Site Accessibility Evaluation

DOT Calhan Office

**1010 Golden St
Calhan, CO 80808**

Accessibility Evaluation

Finding: 1

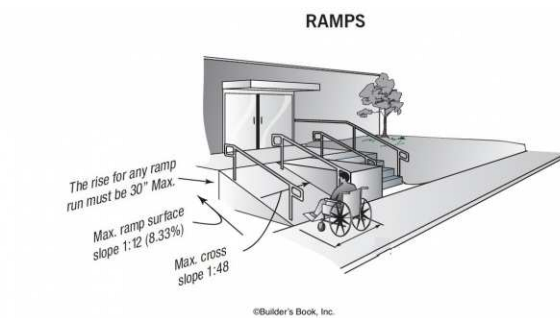
The ramps slope exceeds the maximum running slope (direction of travel) allowable of 8.33%.

Ramp runs shall have a running slope not steeper than 1:12.

2010 ADAS Section: 405.2

19.20 % running slope

Create new concrete ramp and remove existing detachable metal ramp. New ramp at 4 feet in length would meet ADA compliance at 8.33%.
